Prepared by:
The Dredged Material Management Office
Seattle District, U.S. Army Corps of Engineers

MEMORANDUM FOR RECORD

SUBJECT: SUPPLEMENTAL DETERMINATION REGARDING THE SUITABILITY/UNSUITABILITY OF PROPOSED DREDGED MATERIAL FROM BELLINGHAM COLD STORAGE, EVALUATED UNDER SECTION 404 OF THE CLEAN WATER ACT, FOR UNCONFINED OPEN-WATER DISPOSAL AT THE PORT GARDNER NONDISPERSIVE SITE.

Figure 9 – Subarea B Dioxin Concentrations

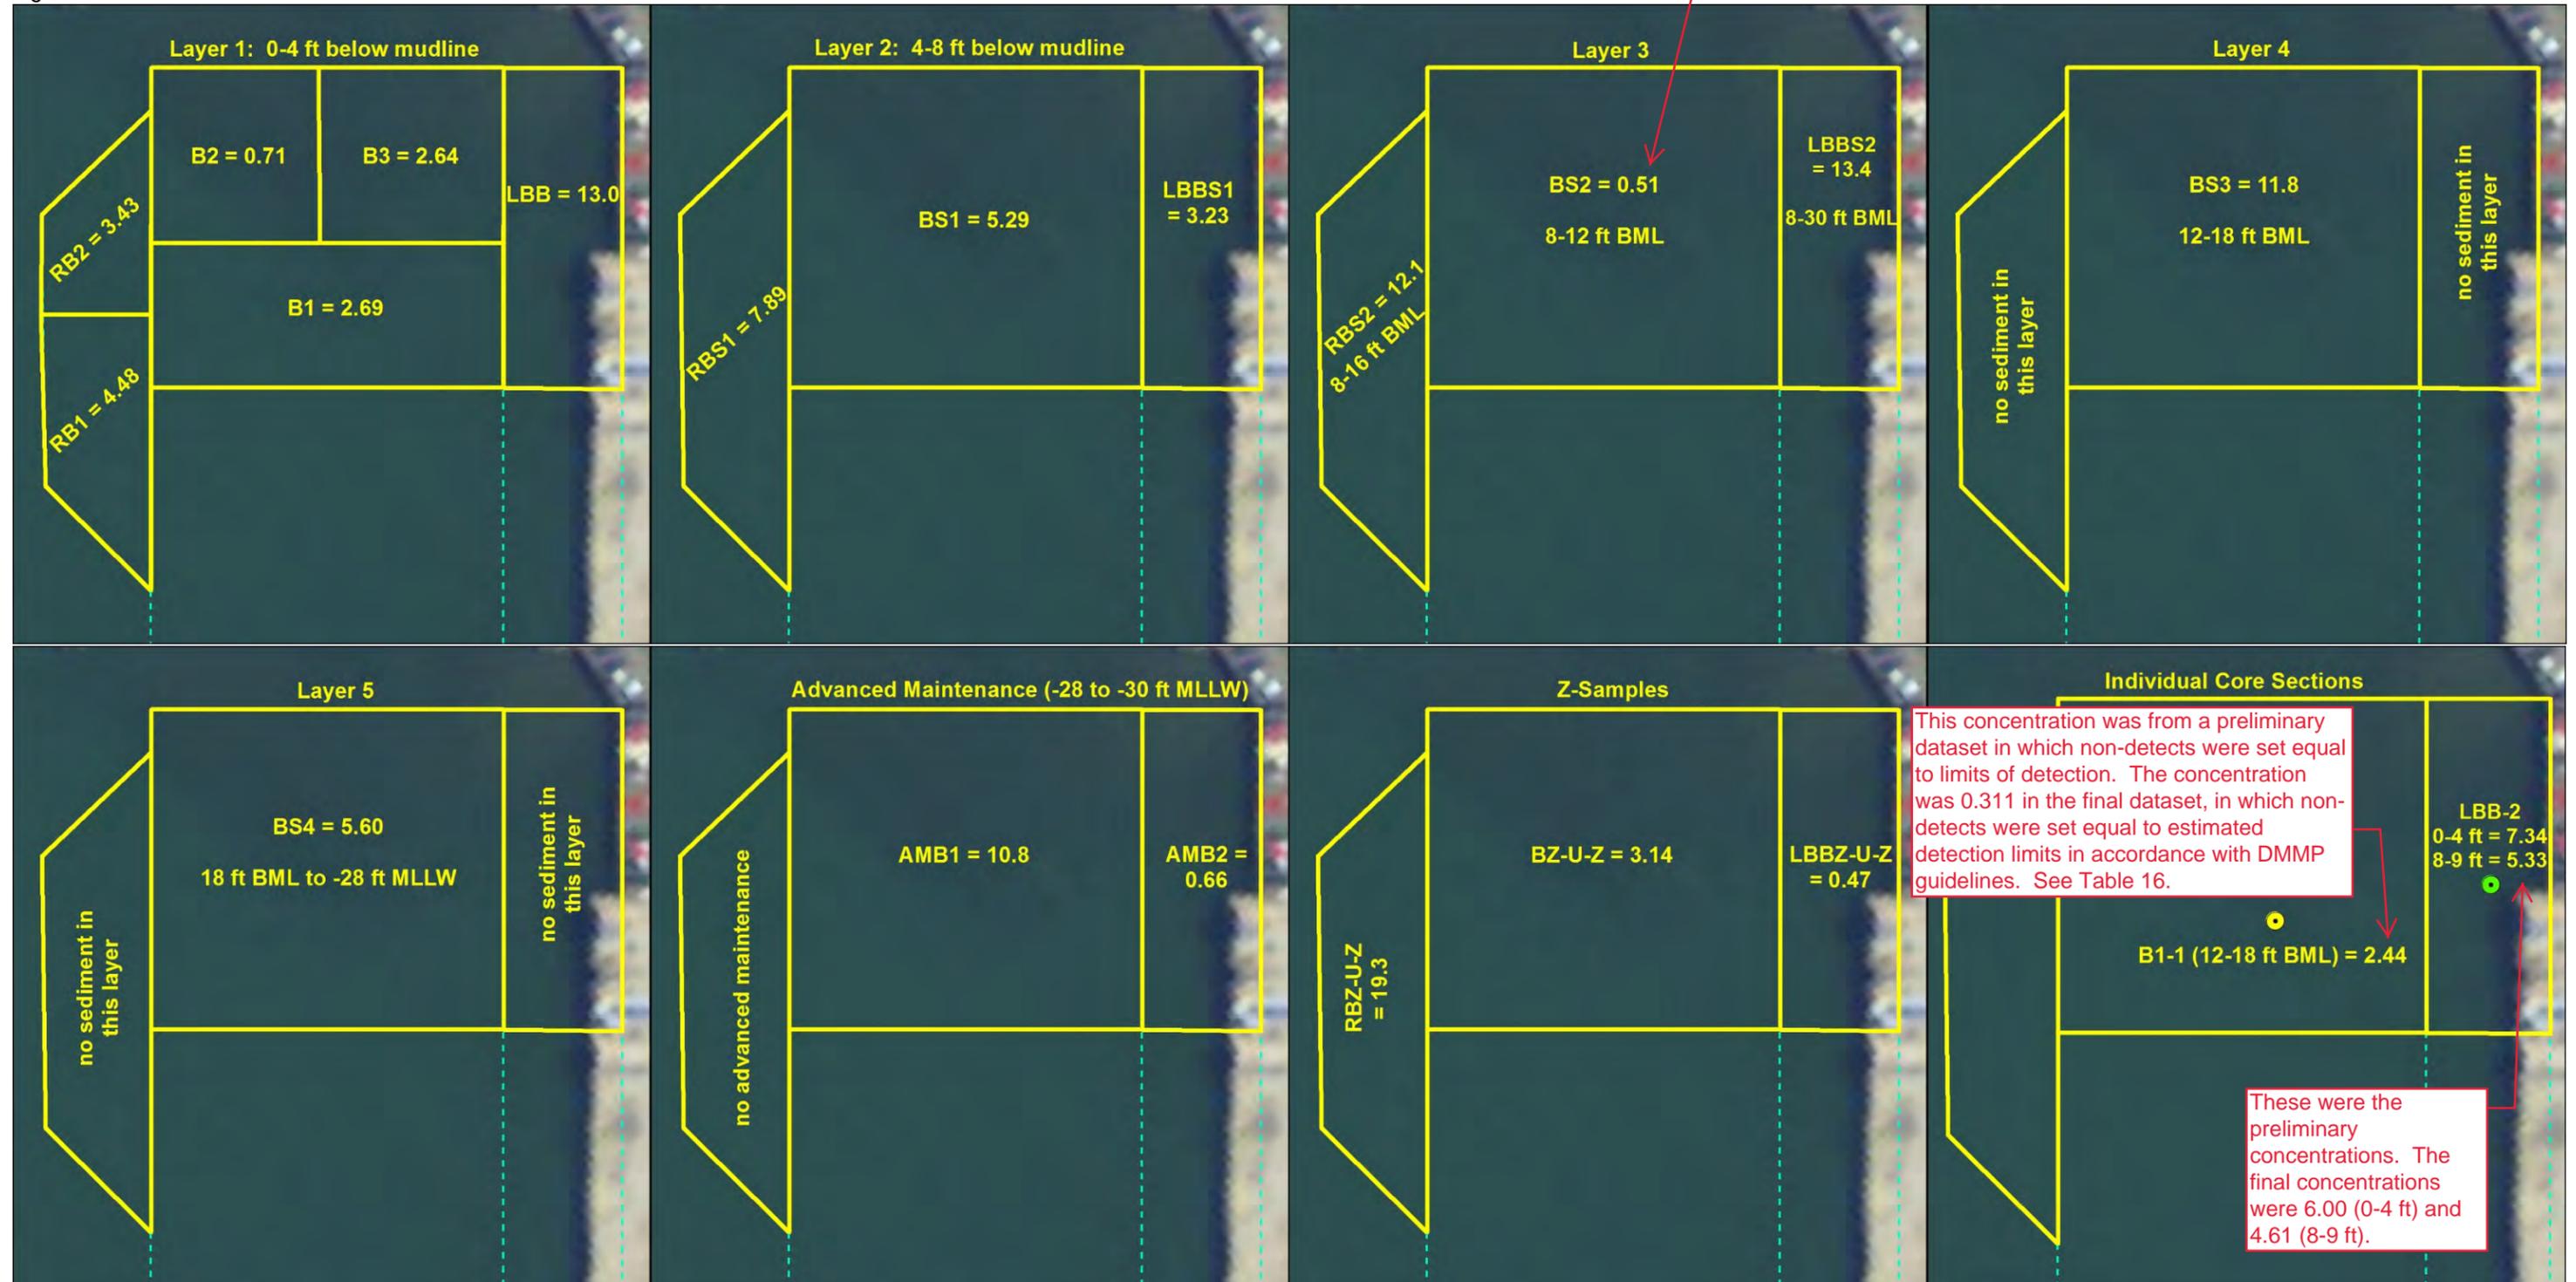
This concentration was a typographic error. It should have been 0.54 (rounded from 0.537). See Table 15.
